N00164.AR.002280
NSA CRANE
5090.3a

REVIEW COMMENTS FROM U S EPA REGION V ON SOLID WASTE MANAGEMENT UNIT
16 DRAFT FINAL INTERIM MEASURES WORK PLAN NSA CRANE IN
6/18/2013
U S EPA REGION V

Review comments from Peter Ramanauskas and Dan Mazur (USEPA Region V) dated June 18, 2013 on the SWMU 16 Draft-Final Interim Measures Work Plan for NSA Crane, May 2013 are indicated in bold font.

METALS CONTAMINATION AREA SOIL SAMPLING RESULTS AND PROPOSED SOILS REMOVAL AREAS
 SWMU 16 - CAST HIGH EXPLOSIVES FILL/B146 INCINERATOR
 NSA CRANE
 CRANE, INDIANA

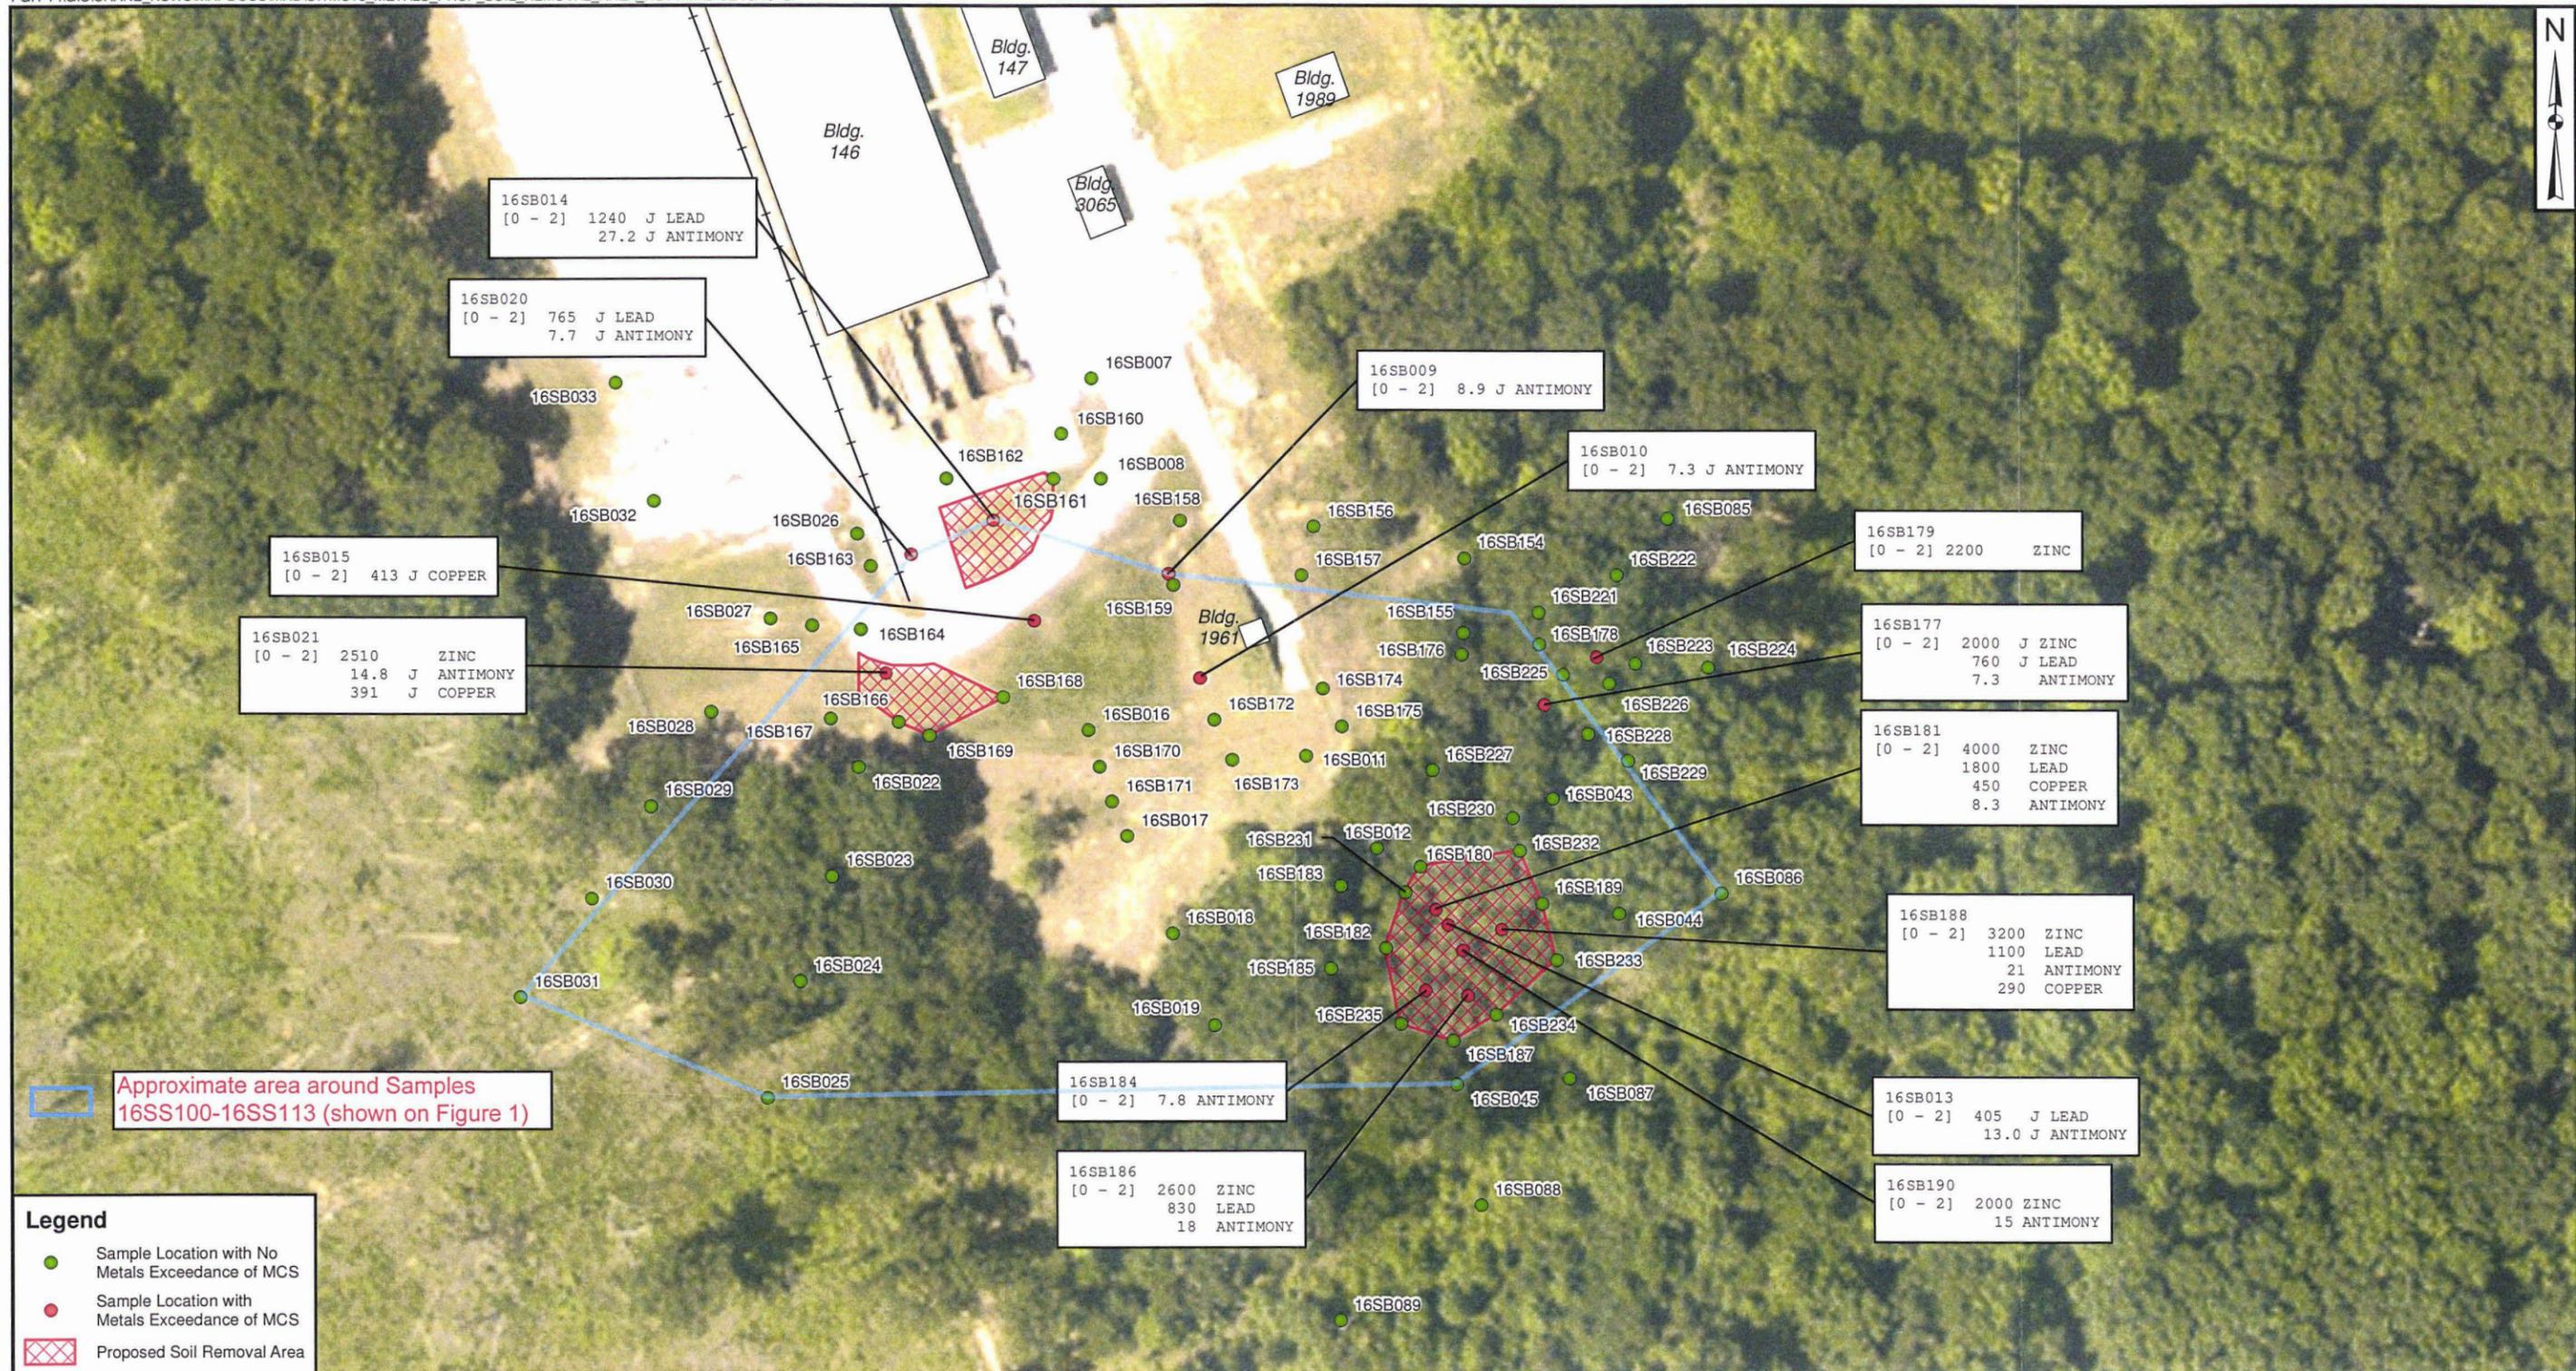
Table 2-4 presents MCS for metals contamination and, using lead as an example, identifies 652 mg/kg and 163 mg/kg as MCS with the 652 mg/kg noted as the “plant preliminary remediation goal, not to be exceeded at any given sample point.” Figure 2-6 identifies the proposed soil excavation areas, but a couple of locations with lead exceeding 652 mg/kg are not marked for excavation (e.g., 16SB020 and 16SB177). Please clarify how the areas proposed for excavation will meet your proposed MCS metals targets.

Although Table 7 from the "Ecological Media Cleanup Goals" report lists a home range of 61.3 acres, the EPA "Wildlife Exposure Factors Handbook" lists the home range of an adult female with brood as 4.5 hectares (11.1 acres). EPA estimated the area for samples 16SS100 - 16SS113 to be approximately 650ft by 470ft, about 7 acres which is 63% of the 11.1 acre home range. Average lead concentration is 681 mg/kg (9532.4 mg/kg/ 14 samples) for this same area. Estimated lead exposure corrected for percent home range is 429 mg/kg (681 mg/kg x 0.63), which exceeds the Navy cleanup goal of 163 mg/kg and the default EPA LOAEL PRG of 192 mg/kg. Samples 16SB020 and 16SB117 are within this group of 16SS100 - 16SS113, so it is unclear why these two samples are not considered for remediation (in addition to 16SS100 - 16SS113). Also note several samples adjacent to 16SB117 were not analyzed.

Response: The rationale why certain samples were not included in the area proposed for remediation is presented in Section 4.2.1 of the Revised Draft Soil Delineation Sampling Data Summary Report SWMU 16 - Cast High Explosive Fill/ Building 146 Incinerator (Tetra Tech, December 2012). To make the SWMU 16 Interim Measures Work Plan a more transparent document, Section 2.2.3.3 will be revised as follows:

Response: A blue outline was added to Figure 2-6 IMWP (attached to this response to comment document) to show the approximate area that encompasses Samples 16SS100 through 16SS113. The area around the 14 samples is approximately 94,000 ft², which is a little more than 2 acres. Therefore, the area only encompasses approximately 18 percent of the 11.1 acre home range for the female woodcock with brood. However, those 14 samples do not adequately represent the entire 2 acre area, because many samples within that area have metal concentrations lower than their respective PRGs. Also, within that area, the majority of the samples with the greatest metal concentrations will be removed. In the Revised Draft Soil Delineation Sampling Data Summary Report SWMU 16 - Cast High Explosive Fill/ Building 146 Incinerator (Tetra Tech, December 2012), the average concentrations of metals over the entire site were recalculated after removing the samples that would be excavated [Note that the recalculated average metals concentrations in Table 4-1 of that report are actually lower than the values listed in that table. That is because the replacement concentrations were inadvertently not included in the average calculation because they had superscripts and were thus not treated as numerical values in Excel.] A revised Table 4-1 is attached to this response to comment document. If the lead data from all 14 samples were included in Table 4-1, except for the data from 16SS100 which was collected in the railroad bed, the average lead concentrations would still be less than the PRG of 163 mg/kg.

The reason that 16SB020 was not included in the excavation area is discussed above in the Navy response to Comment 7. The Navy believes that EPA is referring to Sample 16SB177 not 16SS117 because sample 16SS117 was a reference sample with very low concentrations of metals. The reason that 16SB177 was not included in the excavation area is discussed above in the Navy response to Comment 7.
